NOTICE OF DECISION

CLASS 3 SITE PLAN REVIEW / CLASS 2 ADJUSTMENT CASE NO.: SPR-ADJ23-14

SUMMARY: Development of a new education facility.

LOCATION: 3575 Del Webb Ave NE, Salem OR 97301

1 SITE PLAN
SCALE: 40'-0" = 1"

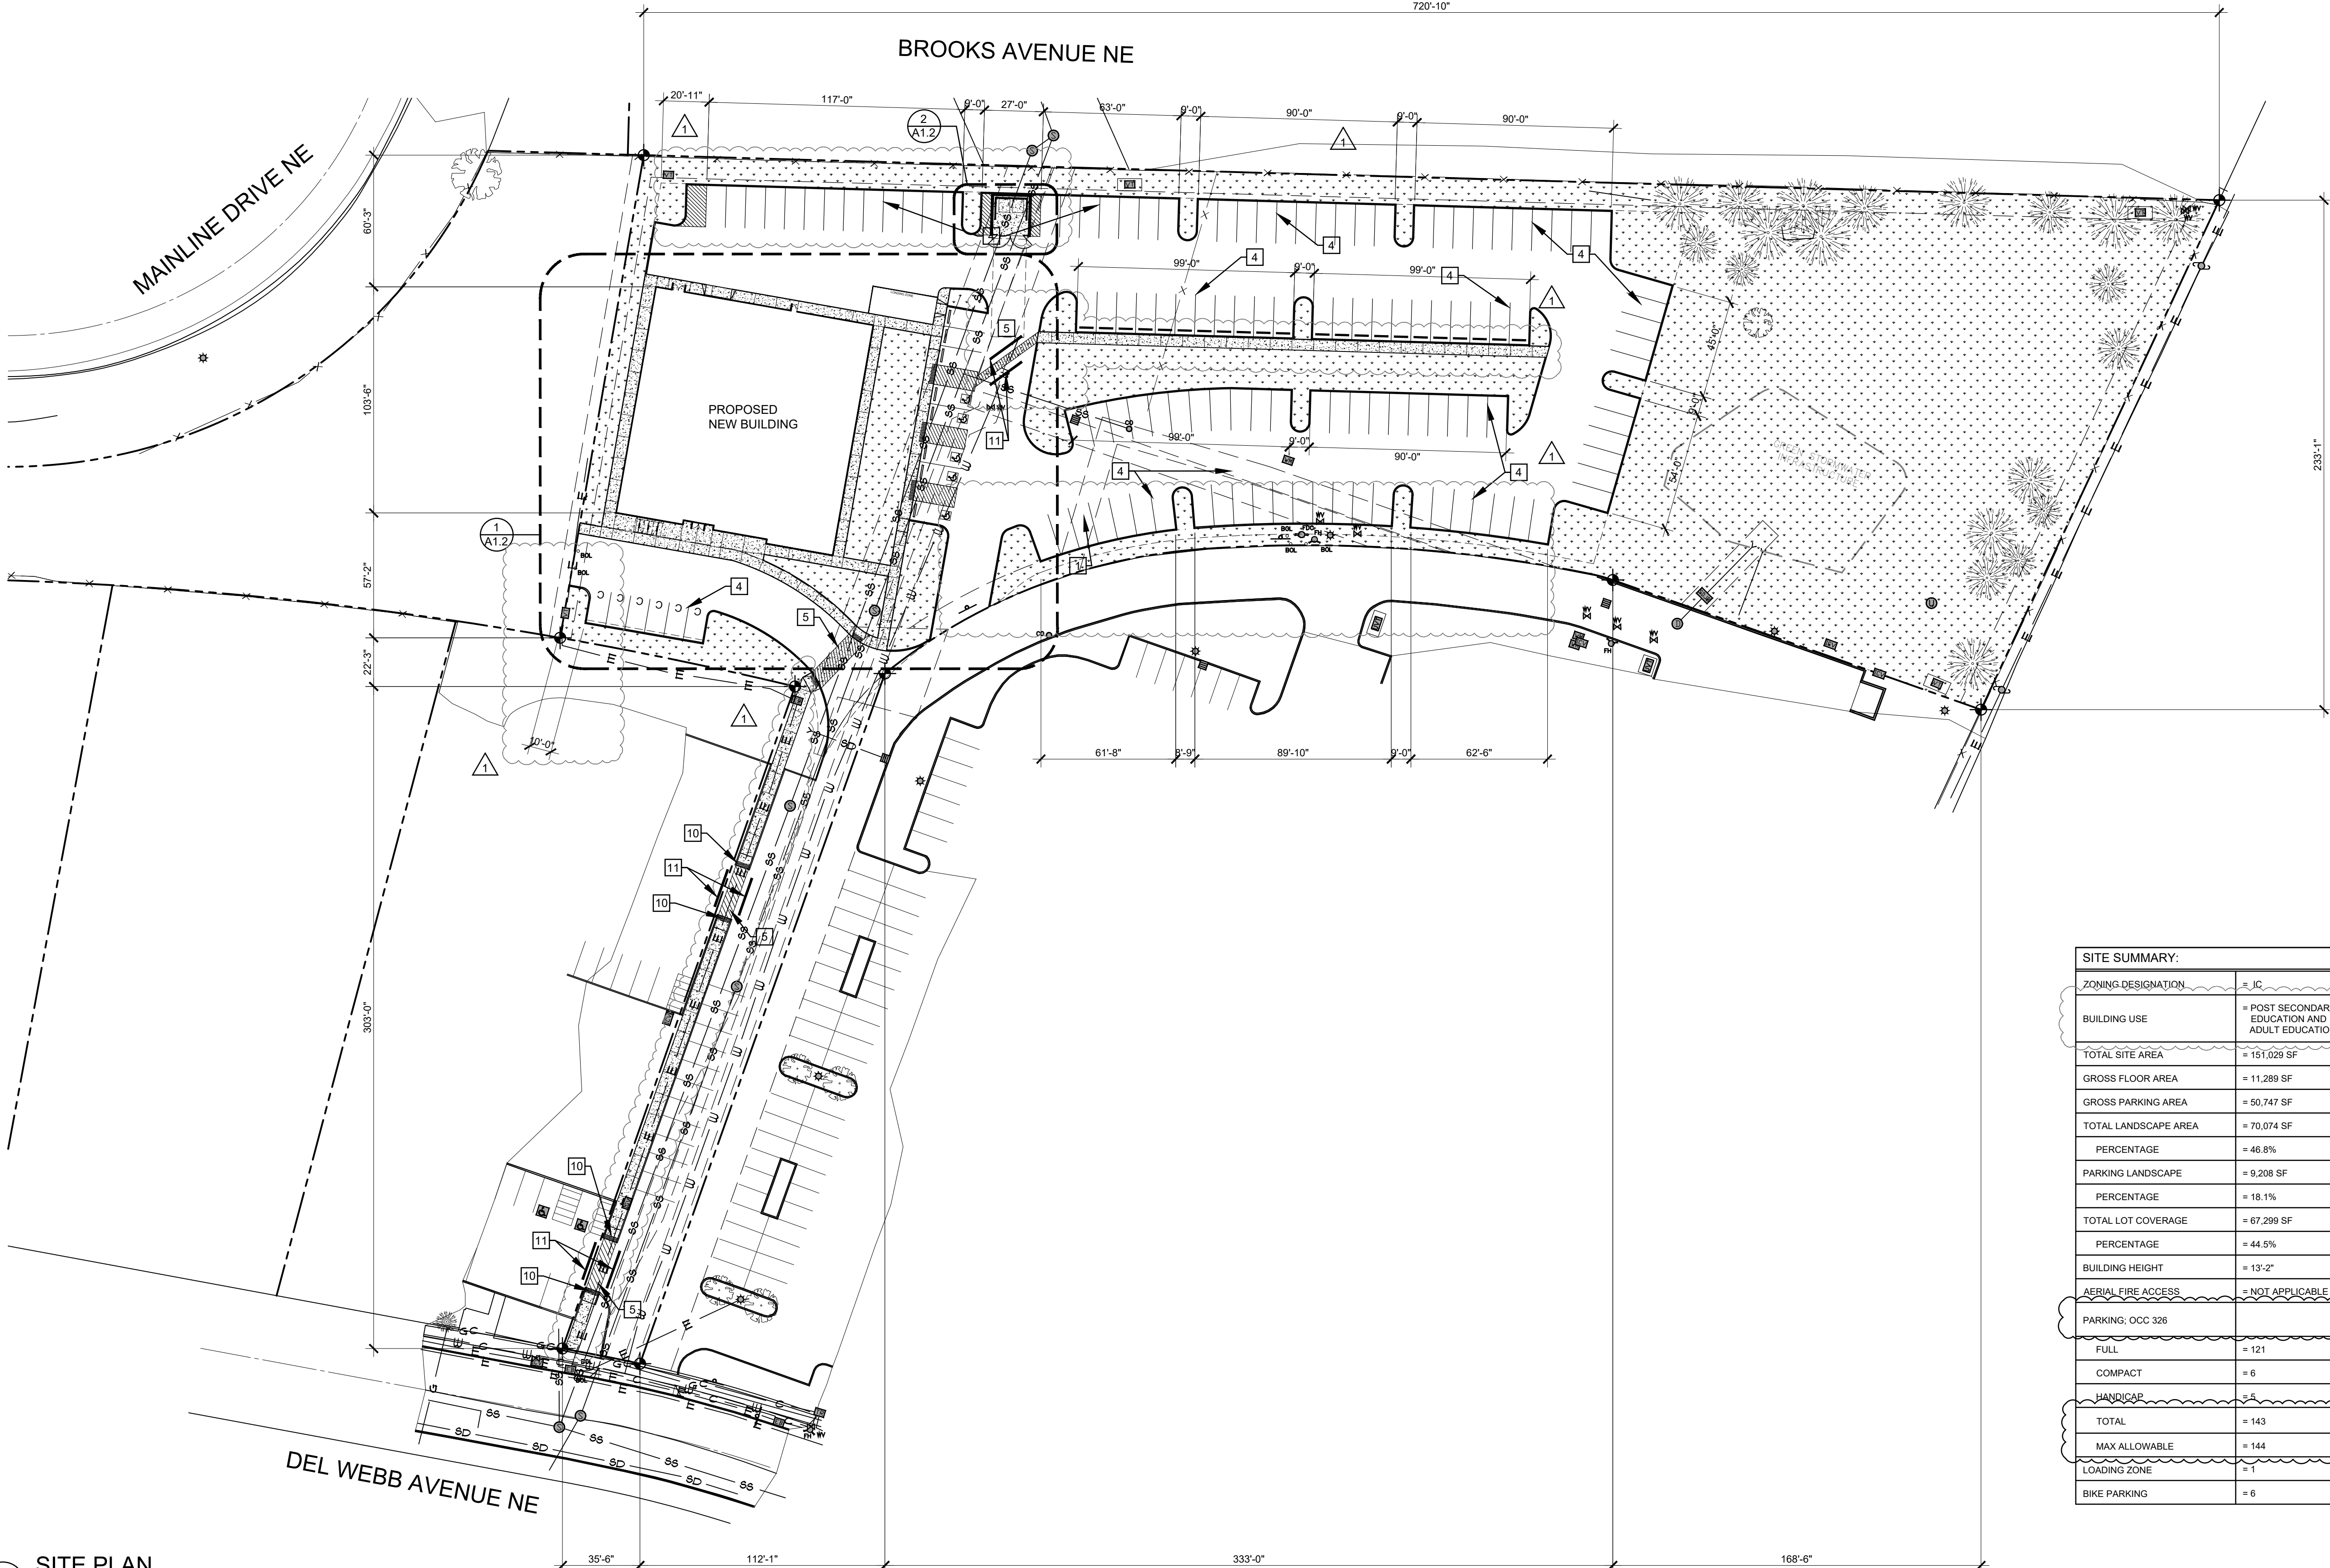
Finding: The applicant's plans appear to show the proposed solid waste service area will be screened with a concrete wall for the portions visible to Brooks Avenue NE; however, the construction details submitted only reference a six-foot-tall chain link fence for the enclosure,

and it is not clear that the enclosure will be sight-obscuring from the street abutting the property. As such, the following condition applies:

Finding: The applicant's plans indicate an adequate turnaround area for the dead-end drive aisle at the northwest corner of the development. A second dead-end area is proposed at the southwest corner of the development, until such time that development occurs on the west portion of the property which would provide safe vehicular access and maneuvering through the site. However, until the west portion of the property is development, the applicant shall stripe one parking space to meet the standard.

Finding: Two-way driveways are required to have a minimum width of 22 feet. The applicant's plans indicate two 24-foot-wide driveways for ingress and egress on the south side of the development, providing access to Del Webb Avenue NE via the flag lot accessway. However,

The applicant's tentative plan shows a new trash enclosure proposed to be located in an easement for City utilities. Structures are not permitted within City utility easements without an approved Revocable License to Encroach agreement. The applicant shall either relocate the trash enclosure outside of the City easement or obtain a Revocable License to Encroach agreement for the trash enclosure.

The applicants tentative plan shows a new trash enclosure proposed to be located in an easement for City utilities. Structures are not permitted within City utility easements without an approved Revocable License to Encroach agreement. The applicant shall either relocate the trash enclosure outside of the City easement or obtain a Revocable License to Encroach agreement for the trash enclosure.

- Condition 8:** Relocate the trash enclosure outside of the City easement or obtain a Revocable License to Encroach agreement for the trash enclosure to remain in the proposed location.

Condition 2: At the time of building permit review, the applicant shall provide construction details for the trash enclosure indicating conformance with SRC 800.055.

Condition 5: At the time of building permit review, the applicant shall dedicate one parking space adjacent to the southwest dead-end turnaround area by striping the parking space to provide safe and convenient vehicle maneuvering until the west portion of the property is developed, pursuant to SRC 806.035(f).

Condition 6: At the time of building permit review, the applicant shall provide an easement or shared access agreement allowing the internal driveway to take access from the adjacent southeast parcel under separate ownership, or redesign the driveway to align with the easements as approved with Partition Case PAR22-06.
